STAFF REPORT: AUGUST 9, 2023 MEETING

APPLICATION NUMBER: 23-8486

ADDRESS: 686 SELDEN

SCOPE: PAINT MURAL ON BRICK AREAS AT SIDE

Staff photo, January 21, 2022

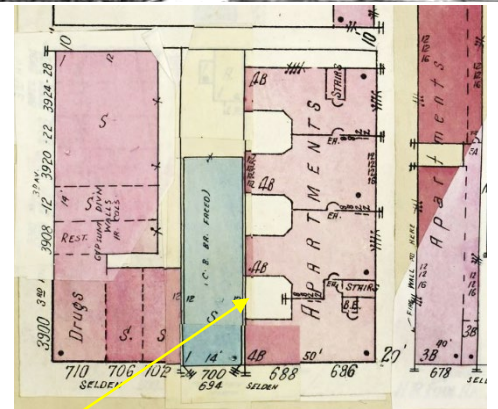
- The Willis-Selden Historic District was established in 2011.
- The contrasting-colored brick denotes where the cornice and small balcony were removed; only a few original corbels remain below the extending walls at the second floor. A building permit was issued on August 25, 1958 for the removal of the cornice and related wall repair.
